Access Compliance Report Public Rights-of-Way (Curb Ramps)

Main Street: SWEET_PEA_ST		Cross Street: SNAPDRAGON_ST		Location:	NW
ADA ID: RPAT211101125748	Ramp Type: Type 4 - Parallel	Initial Pass/Fail: Fail	Overall Compliance: No	Severity Score:	32
Codes/Mitigation Info/Possible Solution			Field Measurements/Component Compliance

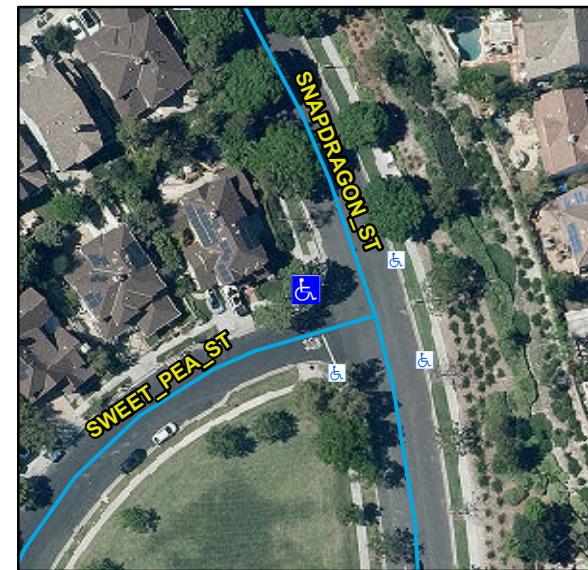
R204.3, R304.3.2, R304.5.3, STD 1115

Compliance	Description	Data	Compliance	Description	Data
N/A	Ramp Length LT (in)	95	N/A	Ramp Length RT (in)	82
Yes	Ramp Width LT (in)	90	Yes	Ramp Width RT (in)	89
Yes	Ramp Run Slope LT (%)	1.1	No	Ramp Run Slope RT (%)	12.1
Yes	Ramp Cross Slope LT (%)	1.5	No	Ramp Cross Slope RT (%)	2.5
N/A	Landing Present	N/A	N/A	DWS Provided	N/A
N/A	Landing Length (in)	N/A	N/A	DWS Contrast	N/A
N/A	Landing Width (in)	N/A	N/A	DWS Length (in)	N/A
N/A	Landing Run Slope (%)	N/A	N/A	DWS Full Width	N/A
N/A	Landing Cross Slope (%)	N/A		DWS Offset Type	N/A
N/A	Landing Movement Obstructed?	N/A	N/A	DWS Offset Left (in)	N/A
	Landing Movement Type	N/A	N/A	DWS Offset Right (in)	N/A
N/A	Landing Shared	N/A			
N/A	Clear Space	Yes			
N/A	Clear Space To Crosswalk (in)	N/A			
N/A	Marked Crosswalk 1	No	N/A	Marked Crosswalk 2	No
	Crossing 1 Direction	S		Crossing 2 Direction	E
	Marked Crosswalk 1 Width (in)	N/A		Marked Crosswalk 2 Width (in)	N/A

Remove & Replace Curb Ramp With Two New Directional Ramps or Equivalent.
